# Amendment Report

EnergyConnect (NSW – Eastern Section)

May 2022

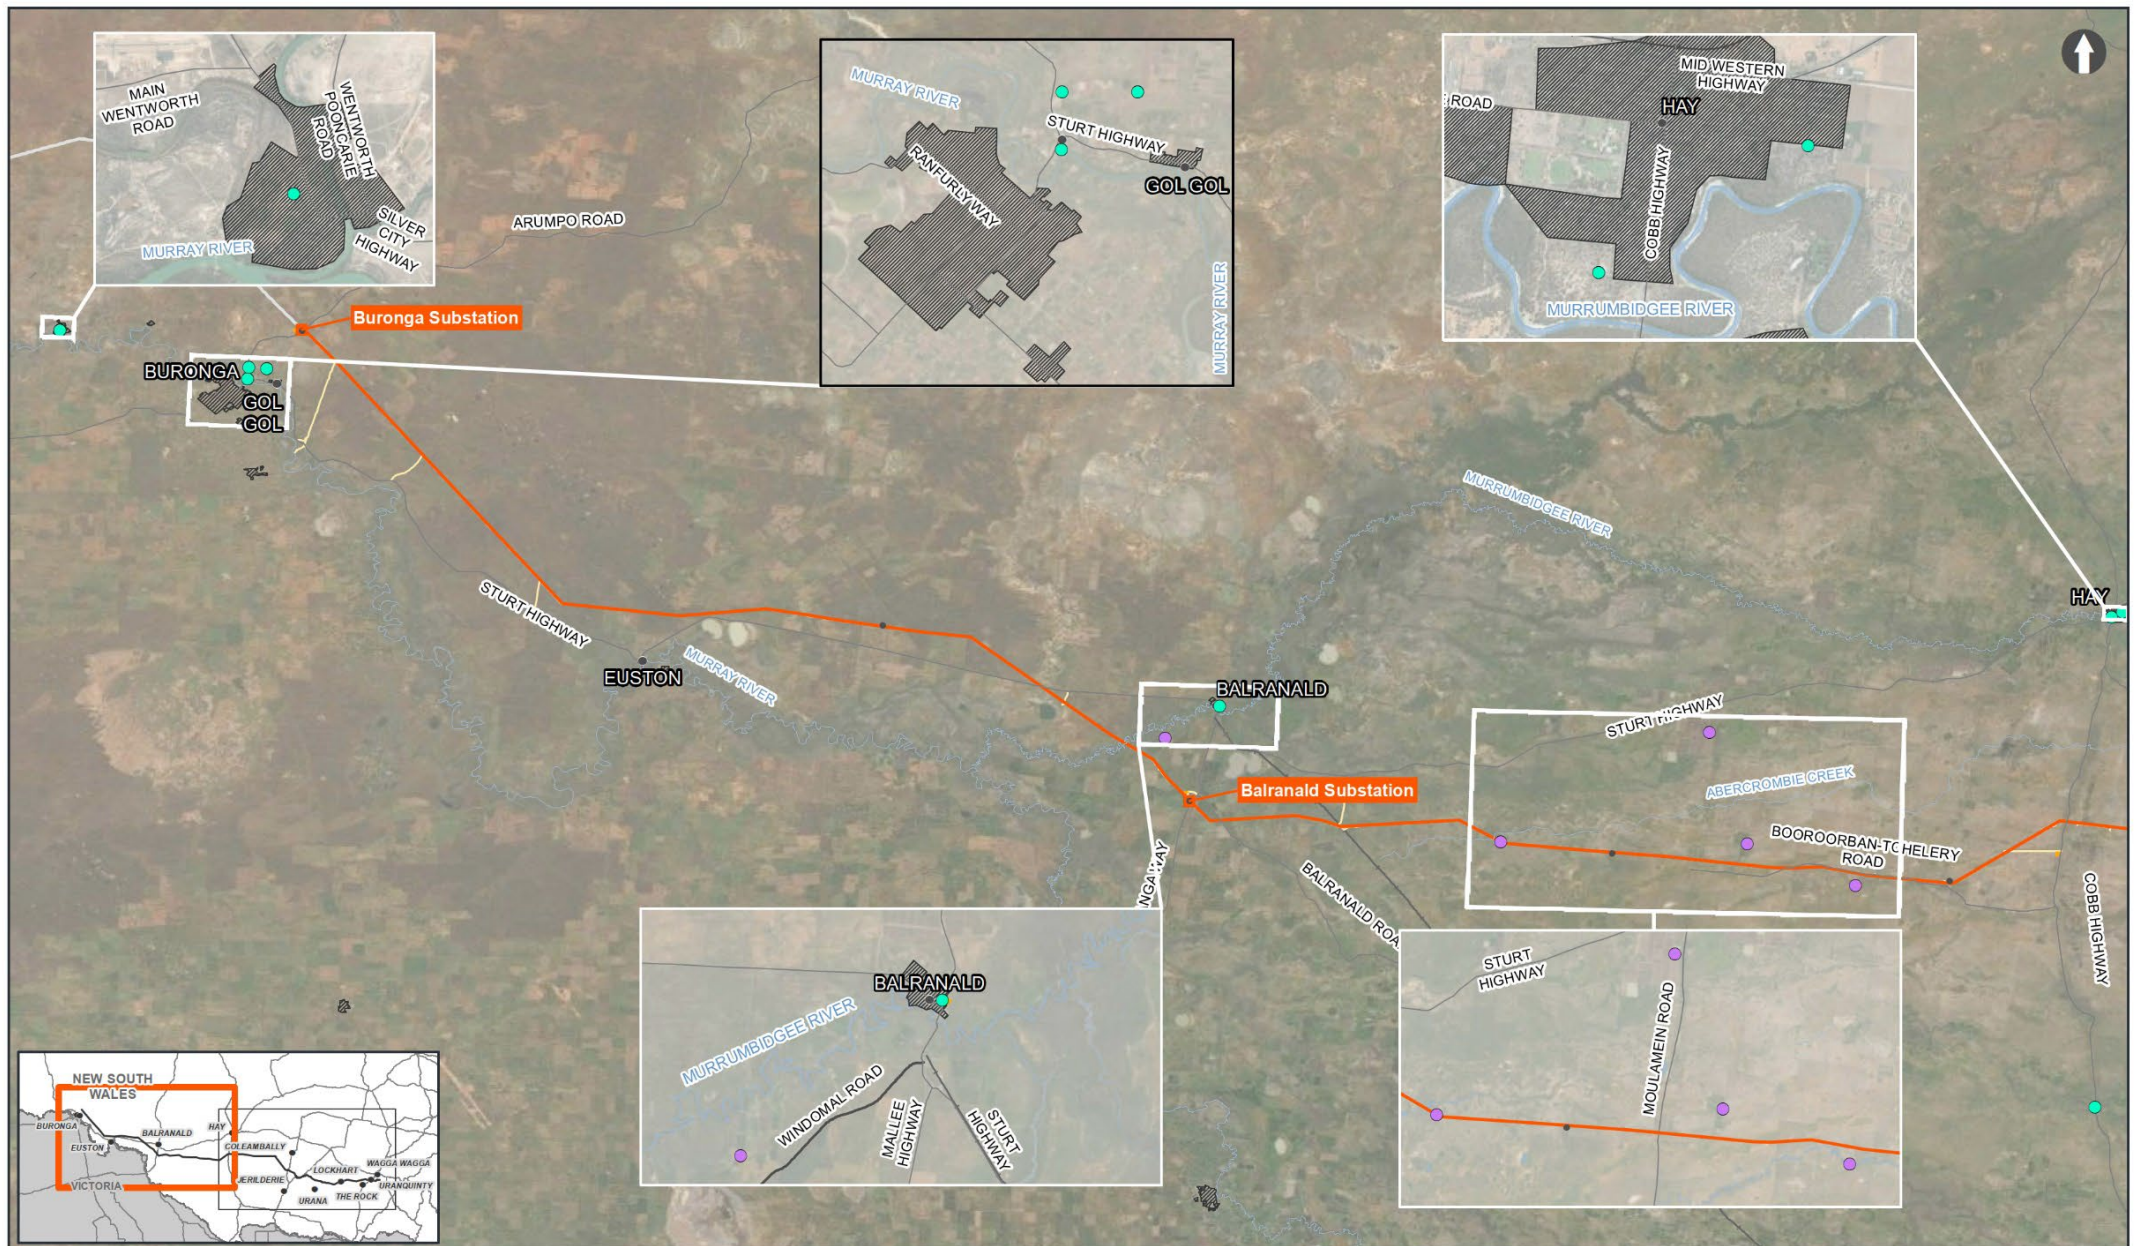
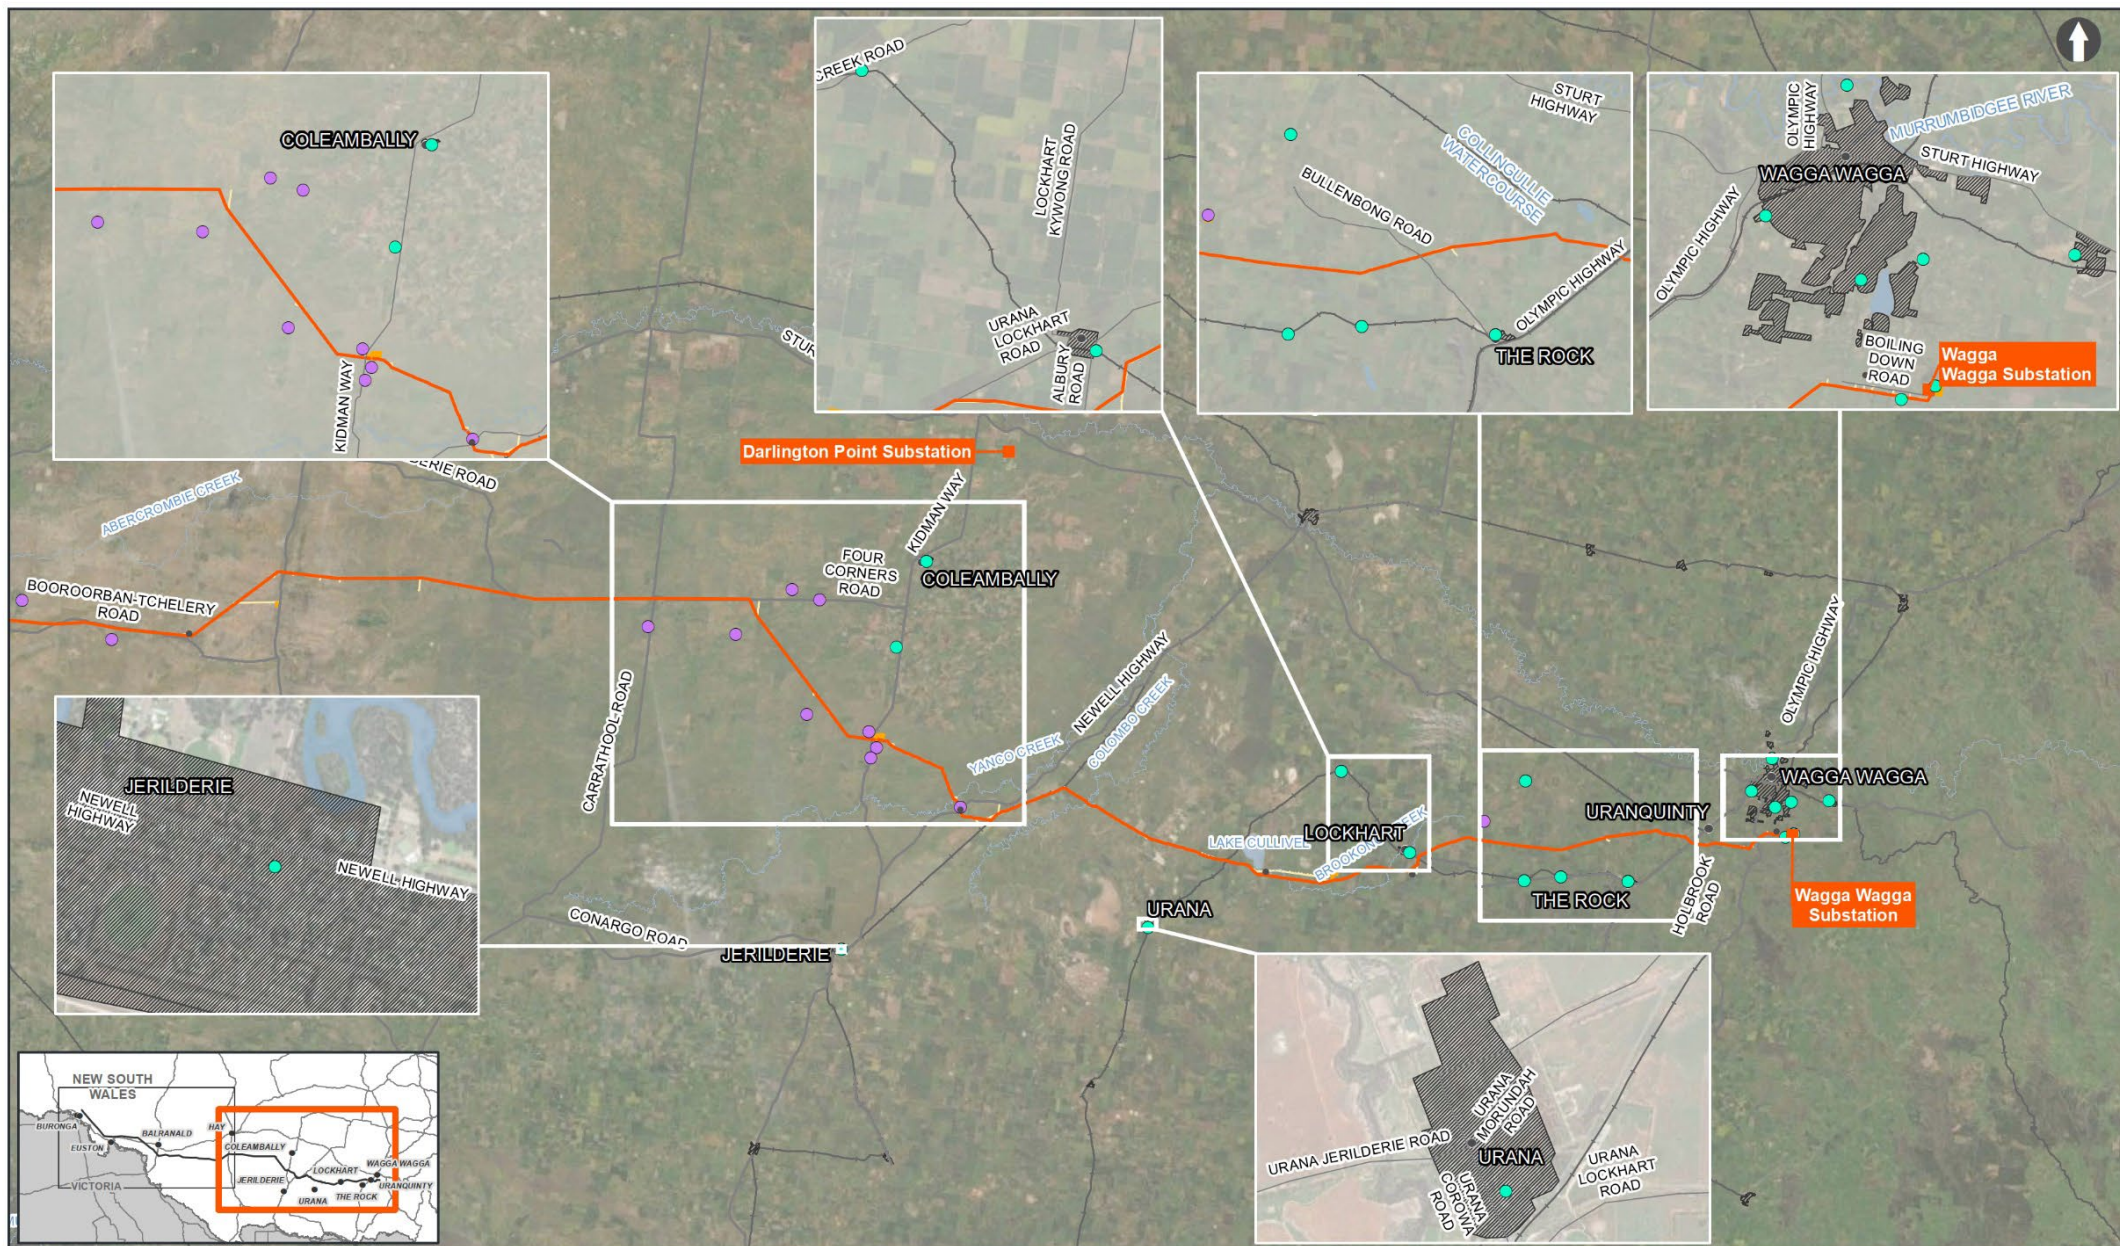
Further development of the construction methodology for the proposal, and ongoing consultation with water suppliers and land holders since public exhibition of the EIS have identified 16 additional water supply points which may be utilised during the construction of the proposal. These additional water supply points may be utilised in addition to the water supply points identified in the EIS. The additional water supply points are listed in Table 3-1 and shown in Figure 3-12.

**Figure 3-13** Figure showing additional mining exploration licence application area

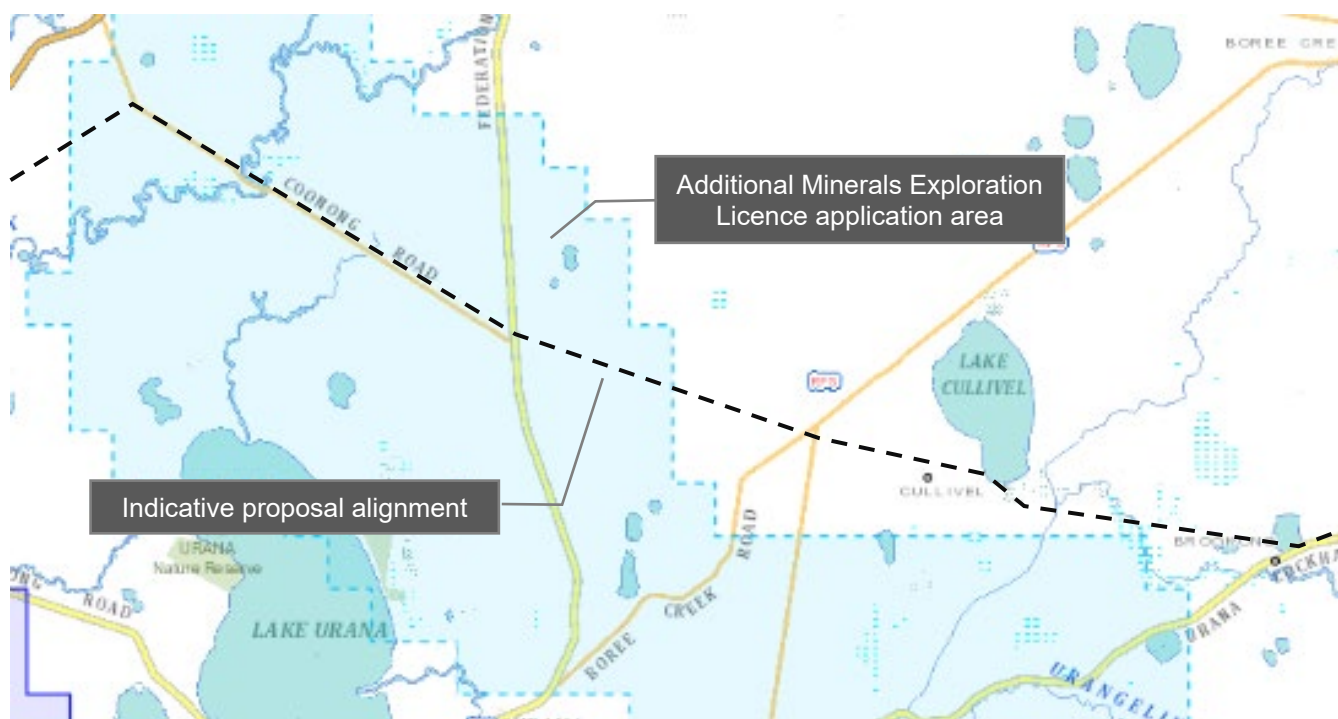
Following public exhibition of the EIS, an additional Minerals Exploration Licence application was lodged for an area located along the proposal alignment generally between the Newell Highway at Bundure and Urana-Lockhart Road to the west of Lockhart (refer to the blue shaded area in Figure 3-13).
